**MODIFICATION REQUEST:**  
**Residential Subdivision**  
**Belle O'Connor Street, South West Rocks**  
**08\_0167 MOD 1**

Director-General's  
Environmental Assessment Report  
Section 75W of the  
*Environmental Planning and Assessment Act 1979*

August 2013

Figure 4: Proposed Stormwater Management Features – Revised Subdivision Plan (source: LDA)

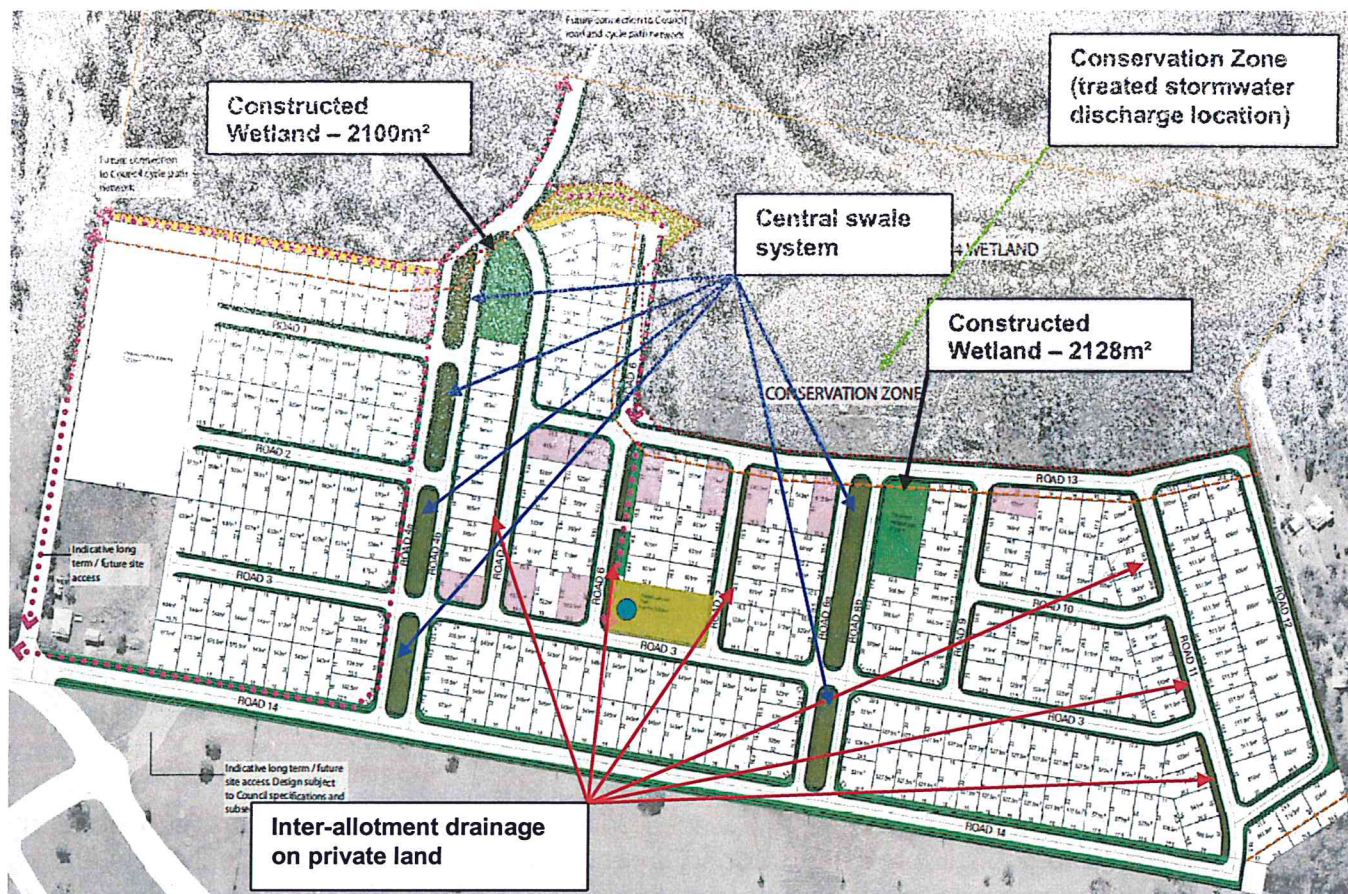
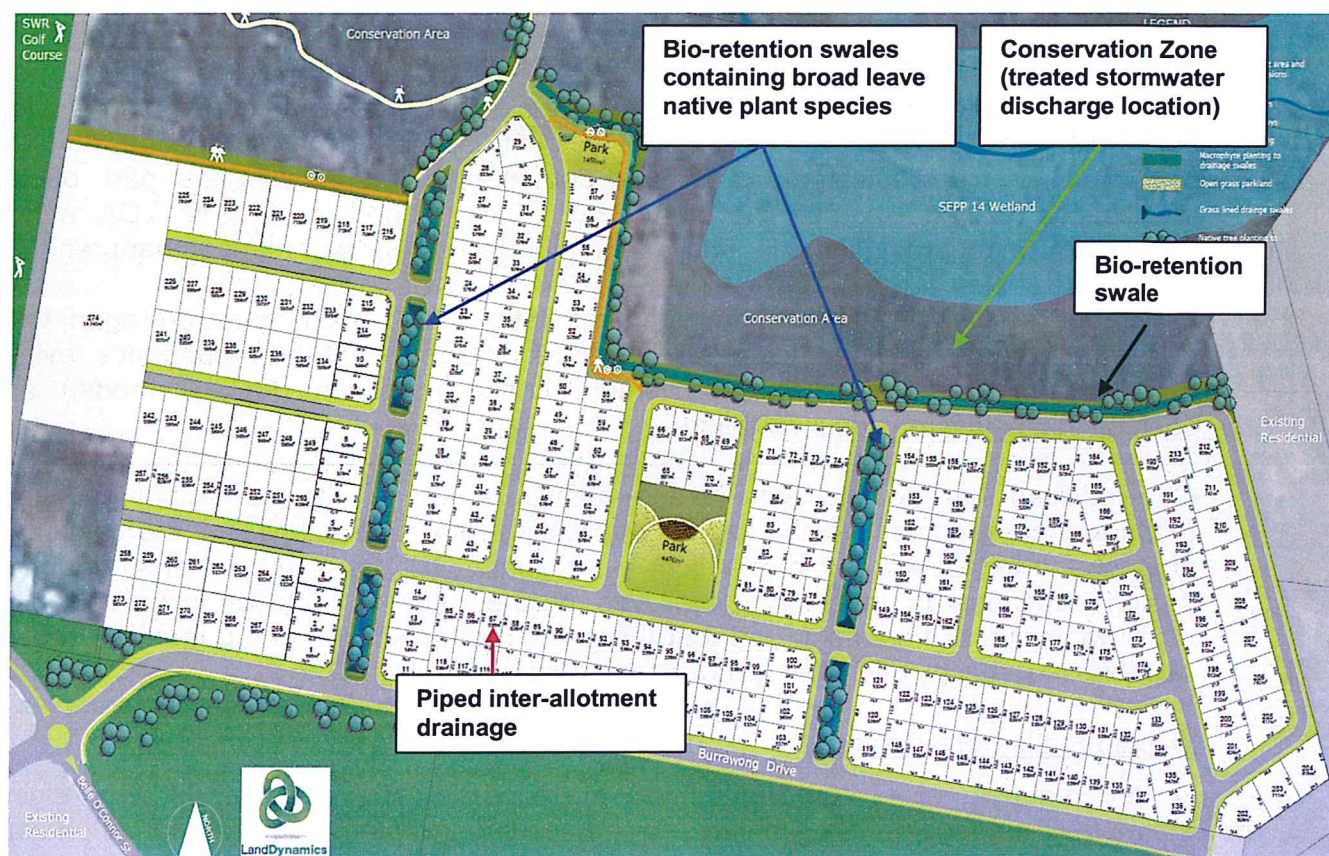
**Figure 3** below shows those features approved as part of the original application including the central grassed open swales, open interallotment drainage (swales) on private land, two stormwater treatment wetlands, and the conservation zone which is the ultimate location for treated stormwater to be discharged. **Figure 4** shows the site layout and stormwater management features as proposed to be modified.

Council raised a number of concerns regarding the redesign of the stormwater treatment train, including consistency with the Saltwater Stormwater Management Strategy (BMT/WBM 2007), appropriateness of planting out the bio-retention swales, the impact of a high water table, gross pollutant pre-treatment, the impact of locating vegetated swales in the road reserve and appropriateness of the grass swale approach on a site with a grade of less than 1%.

The proponent responded to the issues raised by council, which was subsequently forwarded to council for review. Council's response indicated that their only outstanding primary concern was the departure from the Bioretention Technical Design Guidelines. In particular, the insufficient longitudinal gradient combined with high seasonal water table and the lack of site-specific water sensitive urban design.

With respect to concerns regarding water quality and impacts on the downstream wetlands, the department has considered the concerns raised by council and the advice from the proponent's consultant and is satisfied that the amendments proposed as part of the revised stormwater management regime involving the deletion of stormwater treatment wetlands and piping of inter-allotment drainage, will not impact on the adjoining or downstream environments. It is considered that sufficient measures are proposed to be implemented as part of the revised stormwater drainage regime to ensure appropriate treatment occurs in place of the constructed wetlands, including bio-retention swales containing broad leaved native plant species for evapotranspiration processes to occur, and additional bio-retention area along the northern periphery of the site. The revised stormwater management regime for the site is therefore supported.

Figure 5: Cross-section View – Central Open Swale (source: LDA)

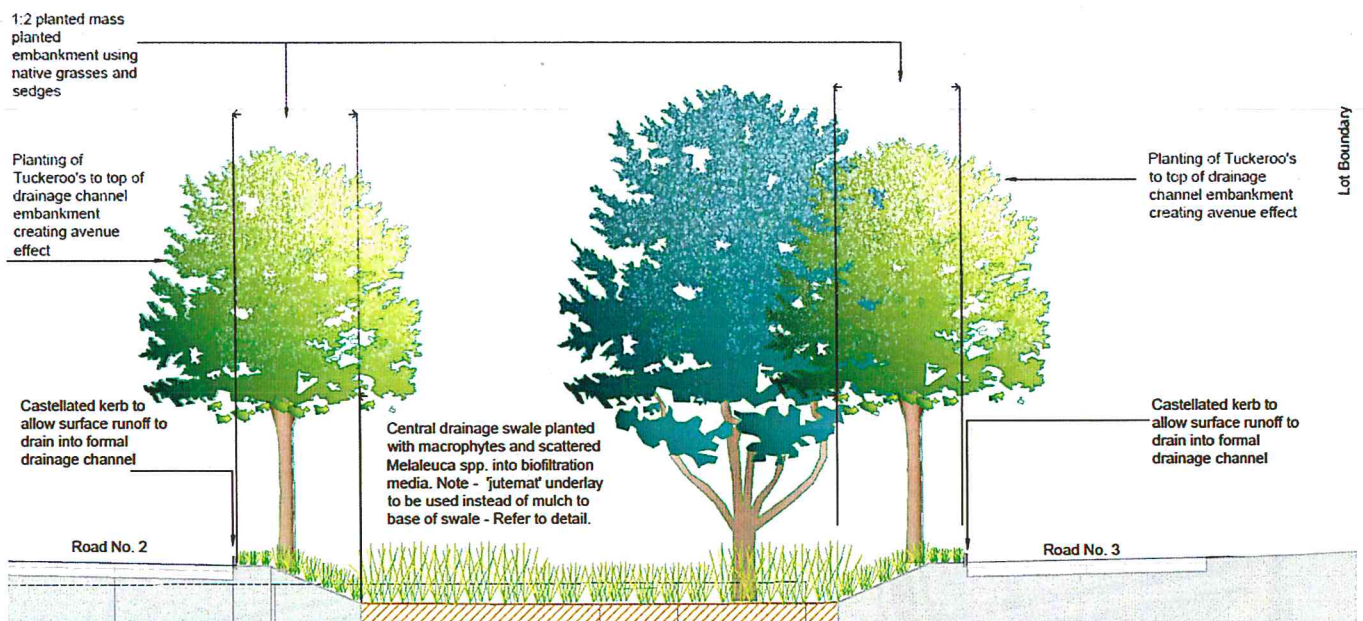
Figure 5 shows a cross-section view of the proposed central grassed open swales, planted with broad leaved native plant species.

**Figure 6: Approved Subdivision Layout**

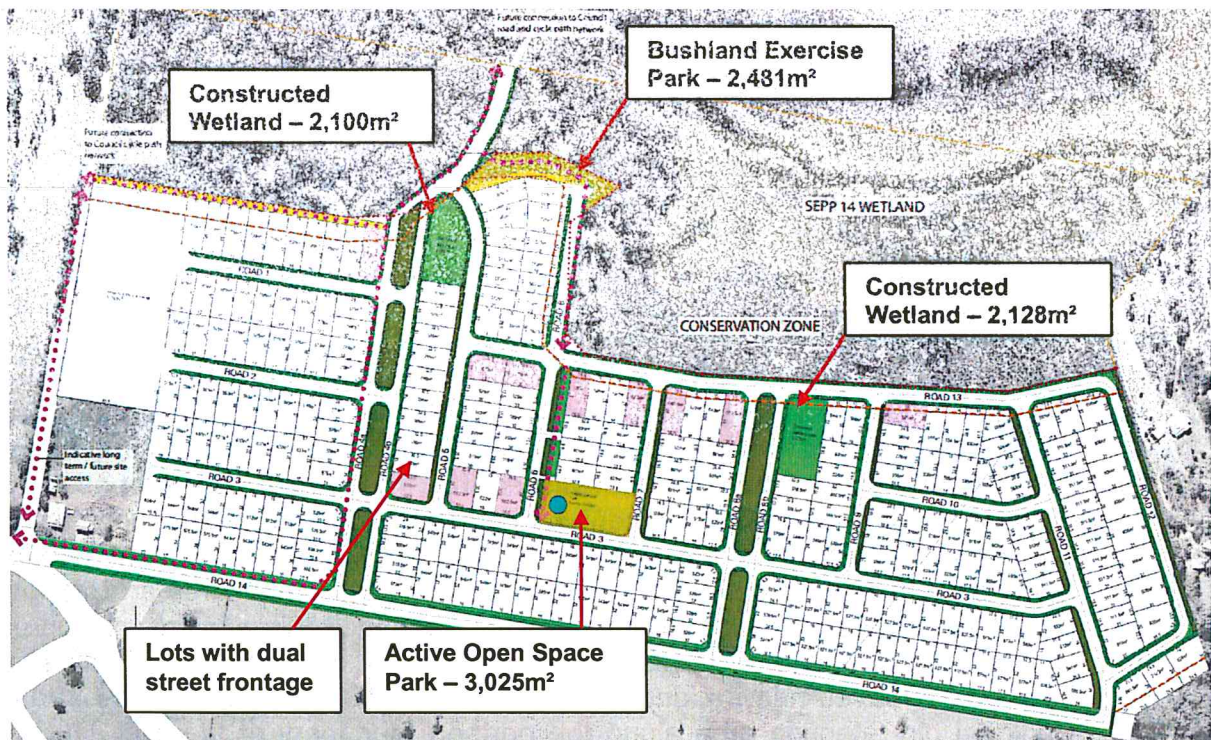
**Figure 6** below shows the location of the approved stormwater treatment wetlands and ten lots with dual street frontage.

The approved project includes a 3,025m<sup>2</sup> active open space park and a 2,481m<sup>2</sup> bushland exercise park. In addition, two constructed stormwater treatment wetlands of 2,100m<sup>2</sup> and 2,128m<sup>2</sup> are approved as passive open space areas when not required for stormwater treatment purposes. **Figure 6** above shows the location of the stormwater treatment wetlands and public open space areas.

The modification application originally sought to delete both the stormwater treatment wetlands and the exercise park. The department and council raised concern with the proposed deletion of the exercise park as this would significantly reduce the amount of public open space to service the future population of the site, particularly as the stormwater treatment wetlands (to be used intermittently as passive open space) are also proposed to be deleted.

The proponent subsequently submitted a revised subdivision plan which proposes to increase the central active open space park from 3,025m<sup>2</sup> to 4,470m<sup>2</sup> in area. In addition, the bushland exercise park (initially proposed to be deleted) is now proposed to be retained as part of the subdivision, albeit reduced in size from 2,481m<sup>2</sup> to 1,450m<sup>2</sup>. In total, the revised proposal includes 5,920m<sup>2</sup> of active open space, which is a 414m<sup>2</sup> increase compared to the approved development (excluding the stormwater treatment wetlands, which were proposed to intermittently act as passive open space). The revised subdivision design showing the location of public open space is provided at **Figure 7** below.

Council advised that the revised public open space provision is an acceptable outcome for the site. The department is satisfied that the revised proposal provides sufficient public open space that is generally consistent with both the size and location of public open space approved as part of the original proposal.

**Figure 9: Proposed Staging Regime (source: LDA)**

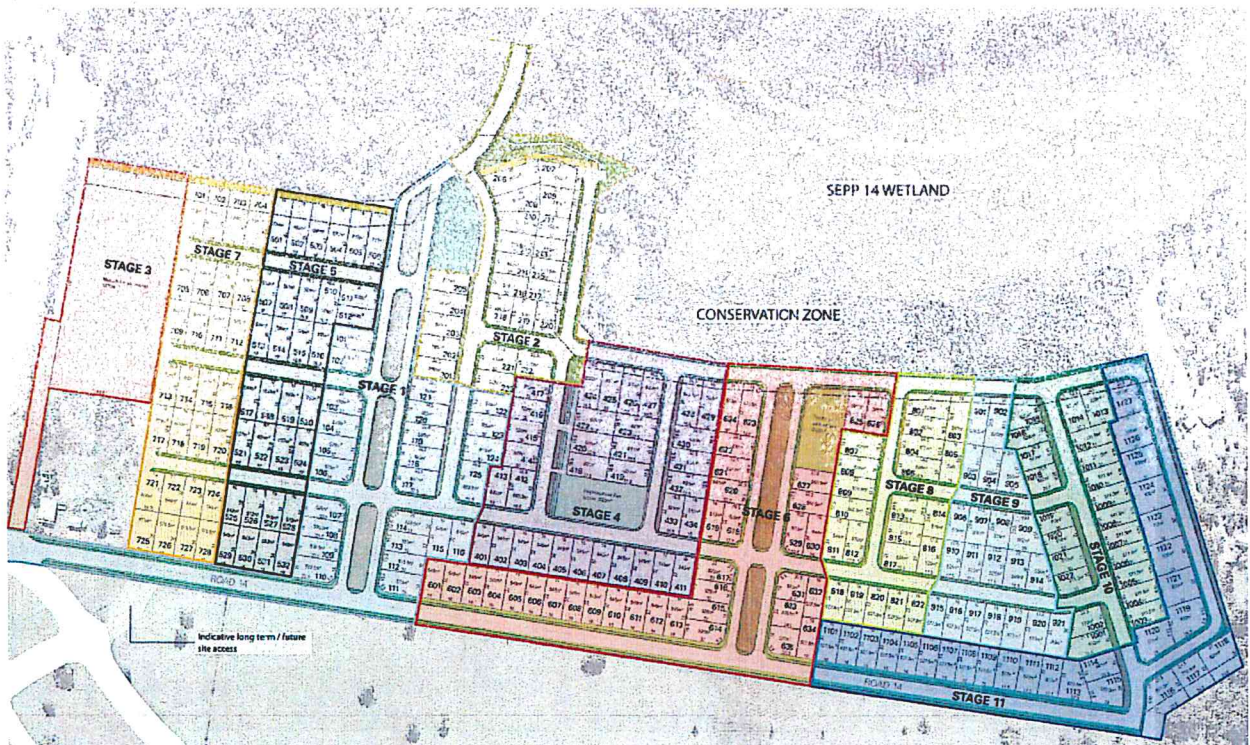
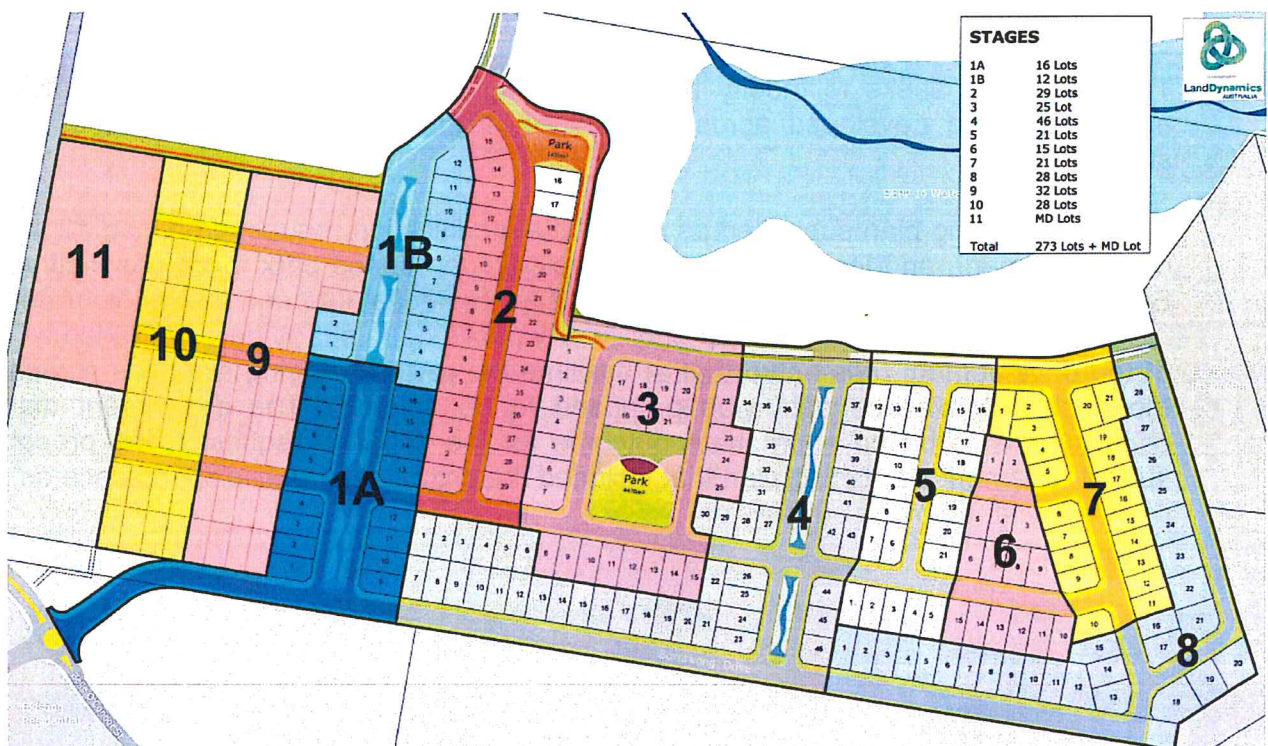
The proponent seeks to modify the staging regime of the site, which was originally approved to be developed across 11 stages. **Figure 8** below shows the approved staging plan.

A revised staging plan submitted as part of the modification request proposed 12 stages of development, and included the central active open space park to be provided within Stage 6. This would see up to 128 low density residential lots and the medium density residential lot (Stage 3) developed prior to any public open space being provided as part of the development (it is noted that at the time the revised staging plan was submitted, the bushland exercise park was proposed to be deleted). The department did not consider this to be an appropriate outcome for the site and requested the proponent submit an amended staging plan that included the provision of public open space as part of an early stage of the subdivision.

The proponent subsequently submitted an amended staging plan which includes the bushland exercise park within Stage 2, and the central active open space park within Stage 3. **Figure 9** below shows the amended staging plan.

The department considers the amended staging regime is appropriate for the site, and that sufficient public open space will be provided in the early stages of the subdivision to service the future population of the site.

The proponent has also requested a degree of flexibility in regards to the sequencing of future stages. A new condition of approval is therefore recommended (Condition A7 – Staging) that requires the proponent to construct Stages 1A, 1B, 2 and 3 first, with the order of subsequent stages able to be varied, only upon receiving written approval from the Director-General. The requirement to construct Stages 1A, 1B, 2 and 3 first is required to ensure sufficient public open space is provided prior to the development of any subsequent stages.
